A G E N D A

Architectural Review Board

November 18, 2015

1128 Woodward Avenue
Tool Shed

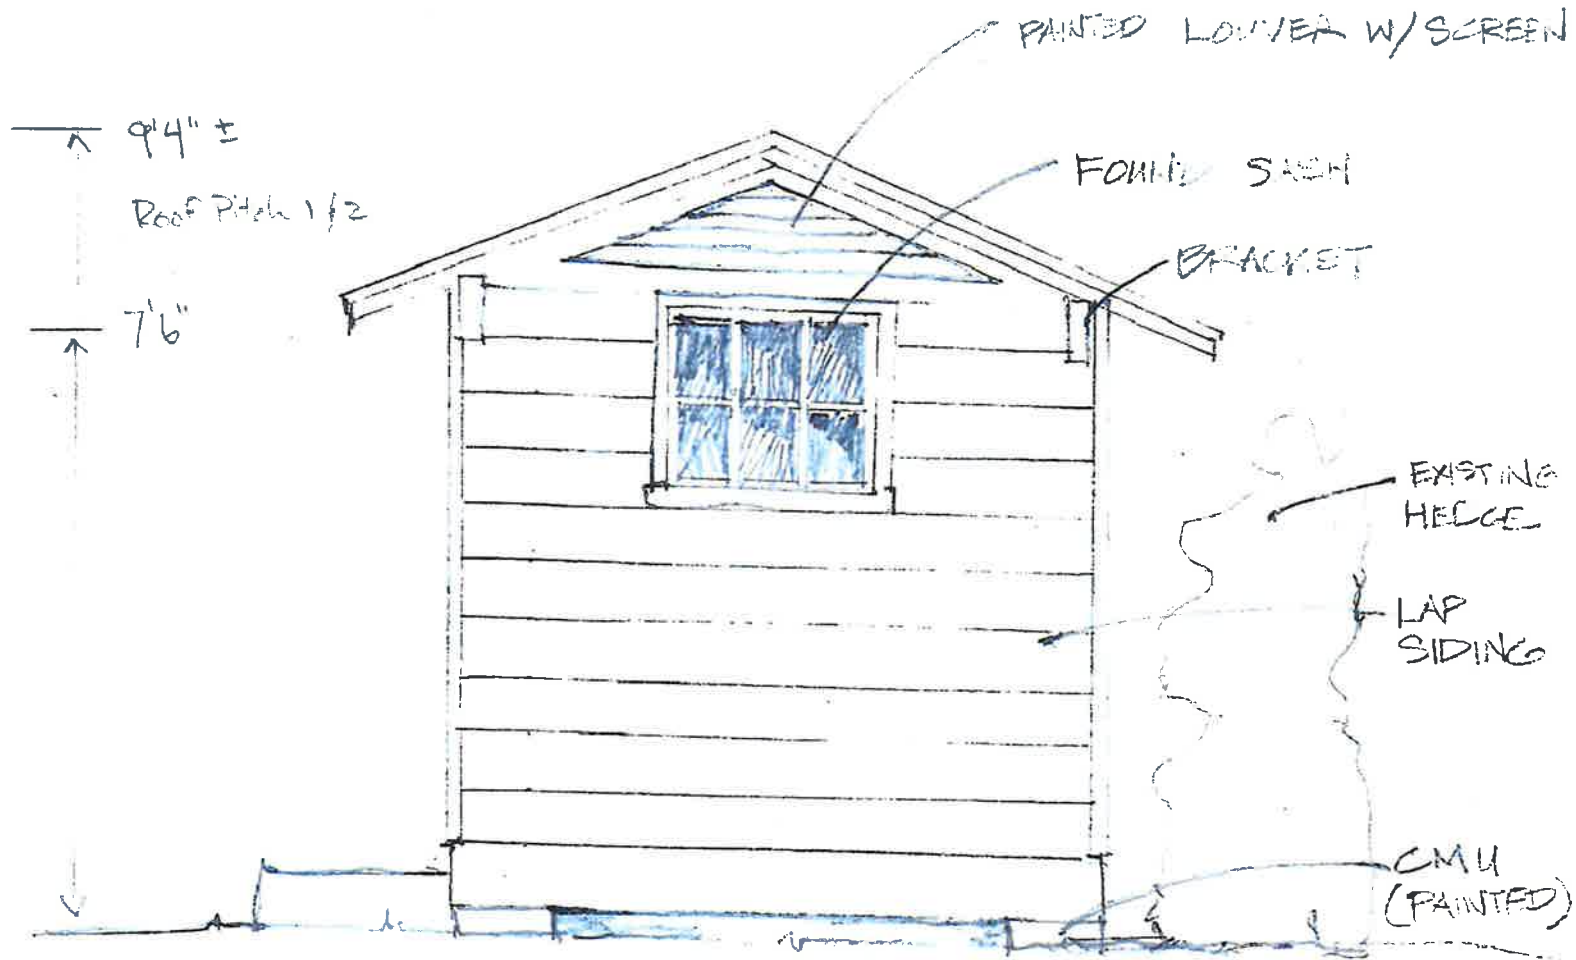
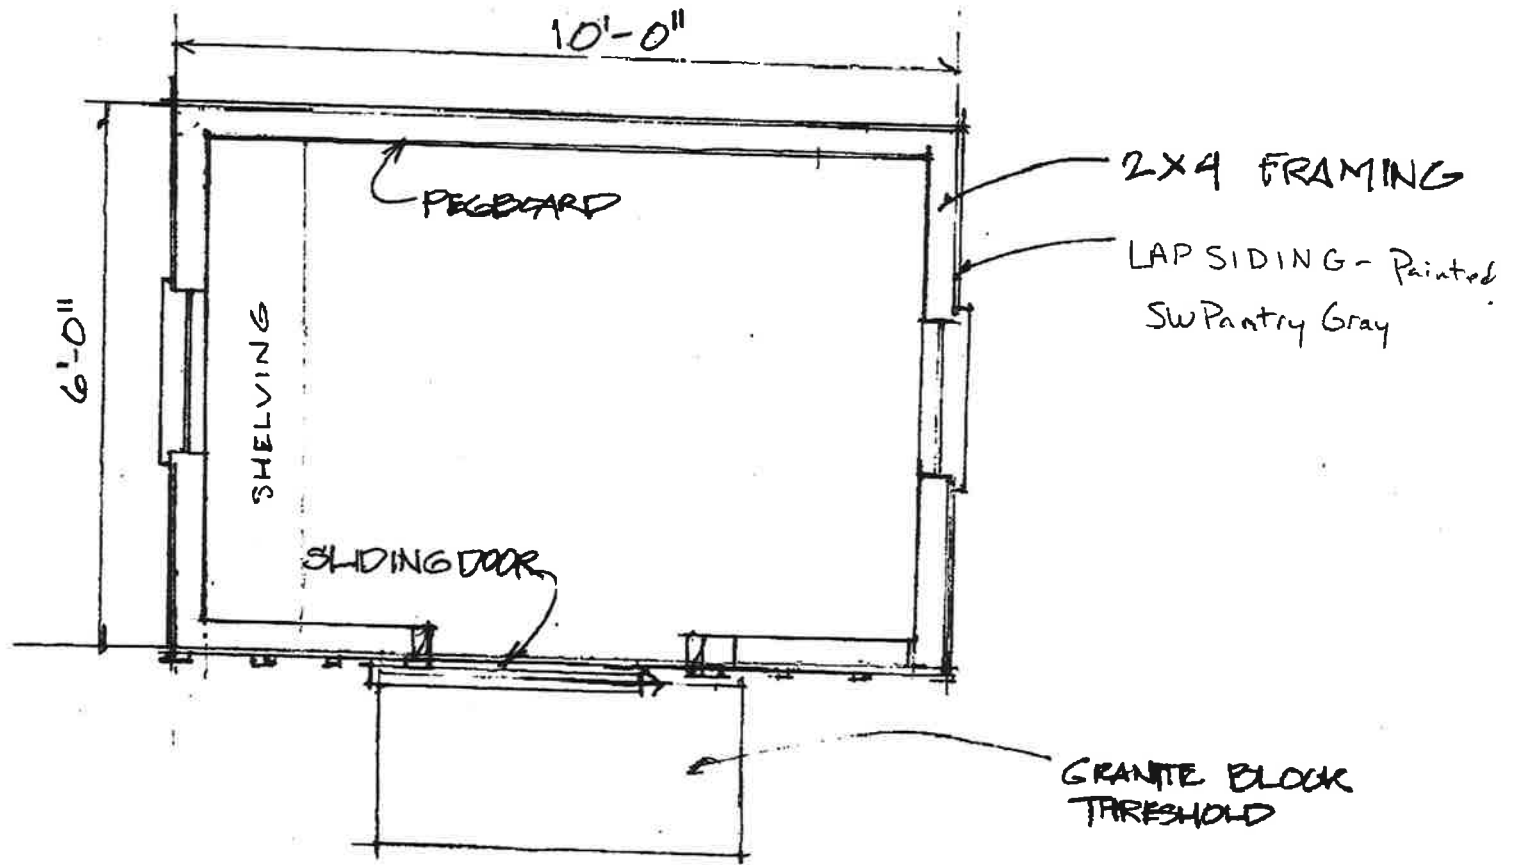
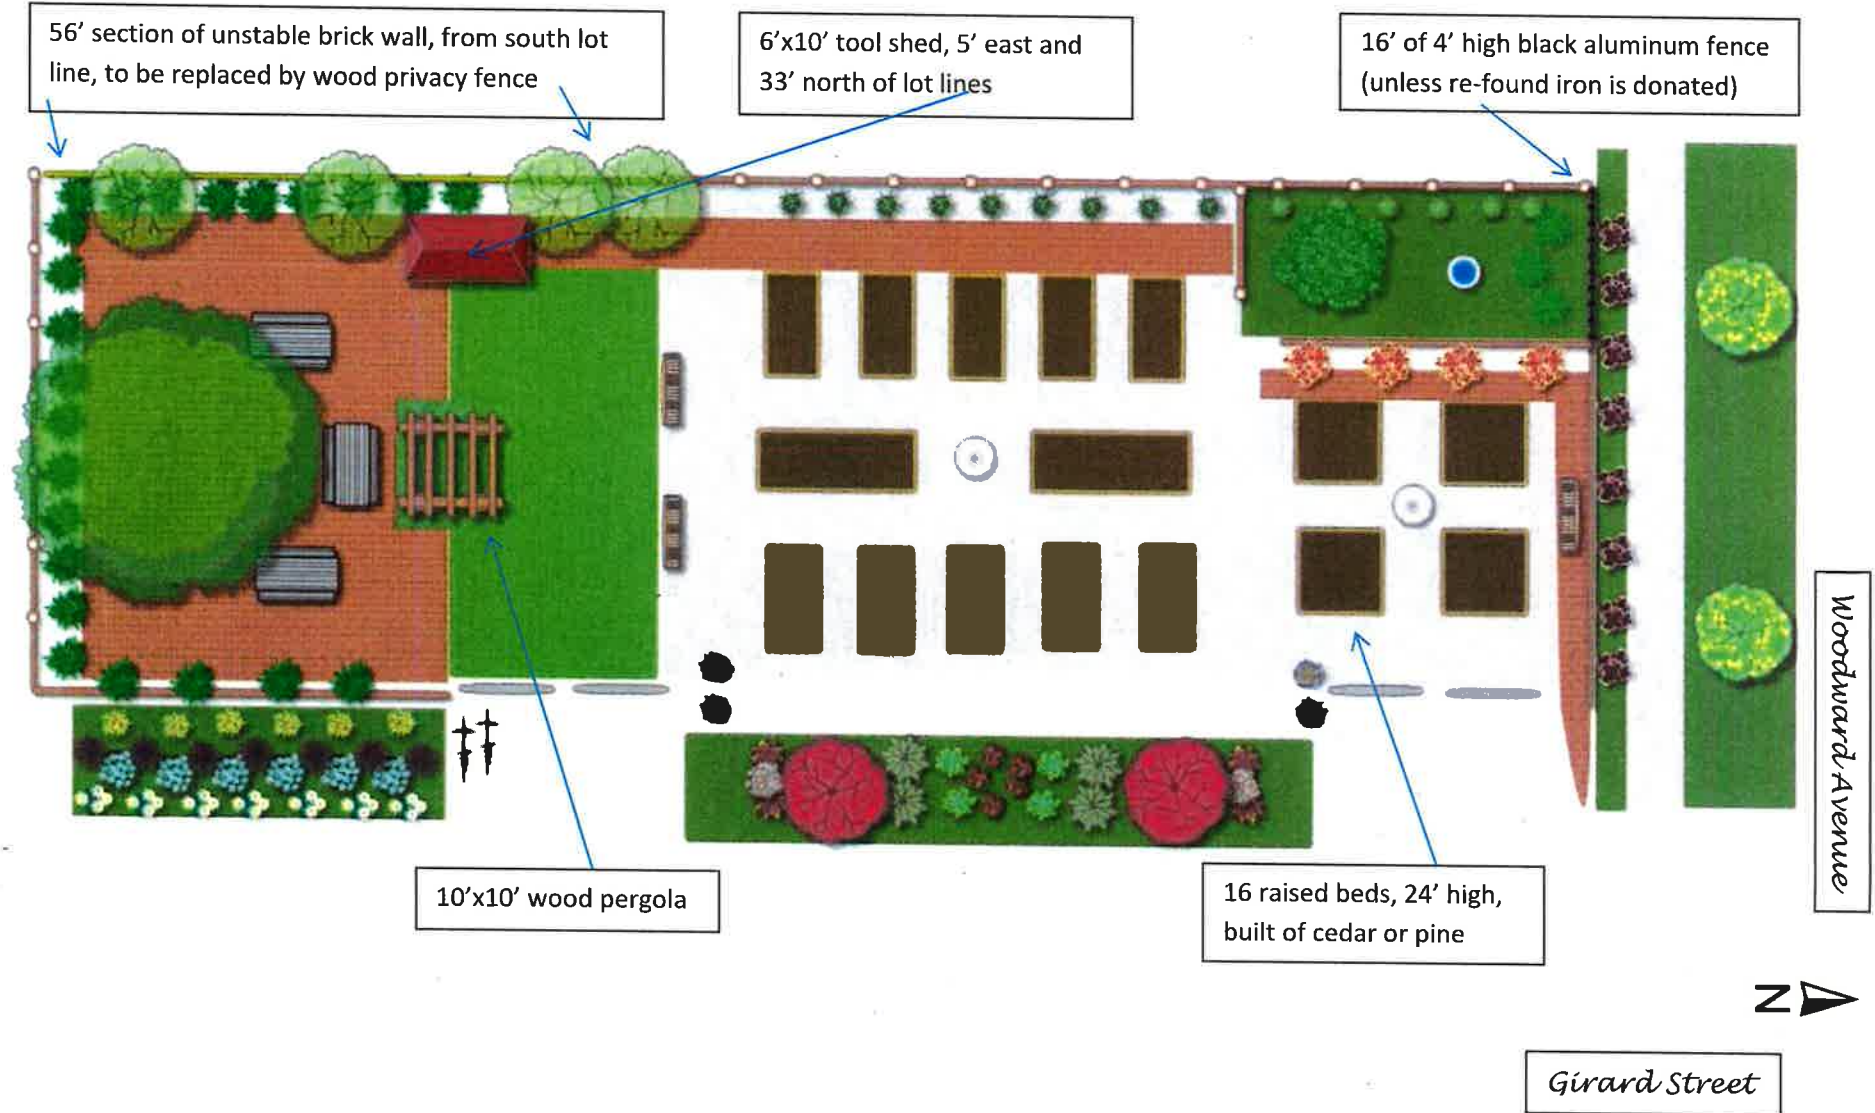
- The Board considers compatibility of new outbuildings with the primary structure, paying particular attention to the eave overhang (that it should have one if the house has one), siding material should be a lap siding (wood or cementitious have been approved) and not a vertical groove panel, and door and window materials should not be vinyl with between the glass lite configurations.
- The proposed building **meets** those basic criteria.

1215 Woodward Ave.
Montgomery AL 36106
Storage building

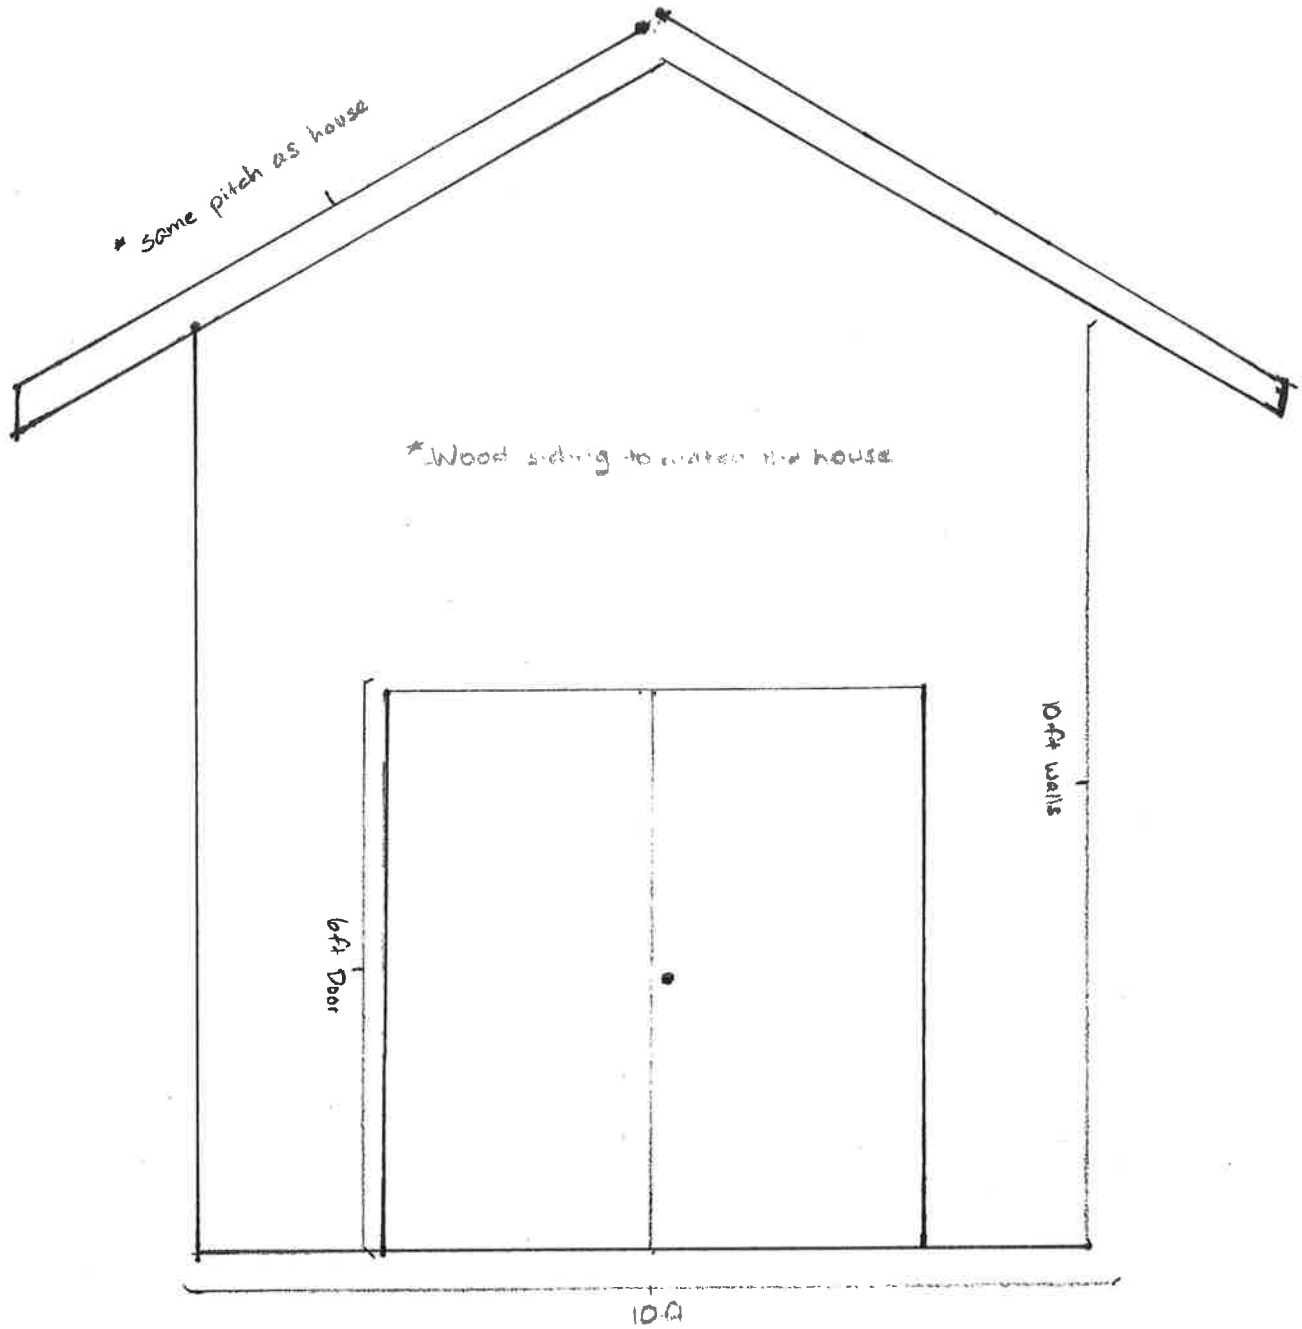
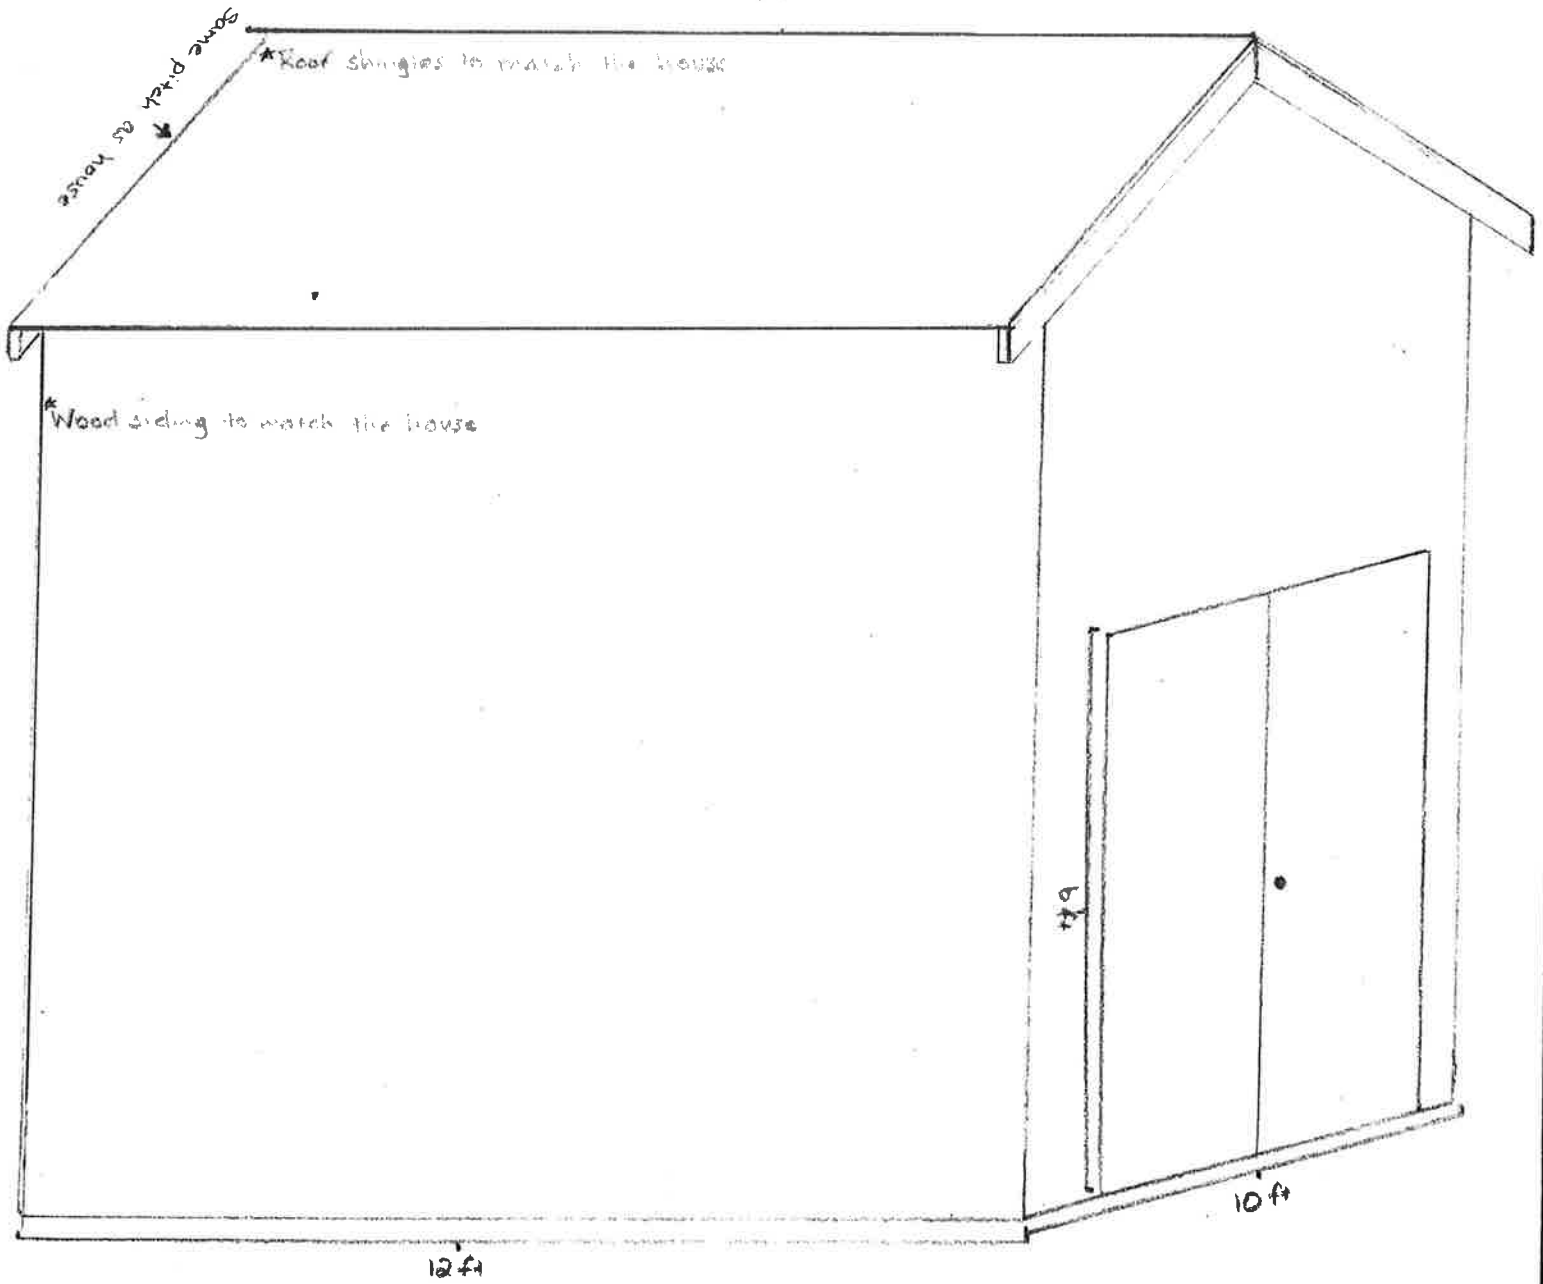
- The Board considers compatibility of new outbuildings with the primary structure, paying particular attention to the eave overhang (that it should have one if the house has one), siding material should be a lap siding (wood or cementitious have been approved) and not a vertical groove panel, and door and window materials should not be vinyl with between the glass lite configurations.
- As drawn, this appears to meet the basic criteria of the Board for accessory structures.
